SERVICE ADVISORY

NO.: 0908 Revision A

SUBJECT: Garmin Integrated Flight Deck systems may display a DME failure

Figure 1. DME Windows with Red-X

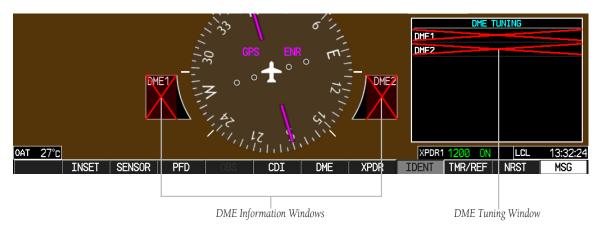
Garmin Integrated Flight Deck systems with GDU Software v8.20 through v9.01 and equipped with the Honeywell KN63 DME may display a Red-X in the DME Information Window and the DME TUNING Window (Figure 1) upon power-up if the Honeywell KN63 DME is not receiving a valid DME signal. The Red-X is removed only after a valid DME signal is received, or after removing power (for approximately 5 seconds) and then restoring power to the KN63.

- 1) Remove power (for approximately 5 seconds) and then restore power to the KN63 DME. This procedure may need to be repeated in the unlikely event that the initial cycling of power does not clear the Red-X.
- 2) The tuned DME station becomes valid and gains reception. This can be accomplished if NAV1 or NAV2 was selected in the DME TUNING Window prior to the power-up DME failure indication, the Red-X condition can be cleared by tuning the appropriate NAV radio to a valid DME station within signal reception for the area.

GDU Software versions 9.02 and above, have corrected this issue.
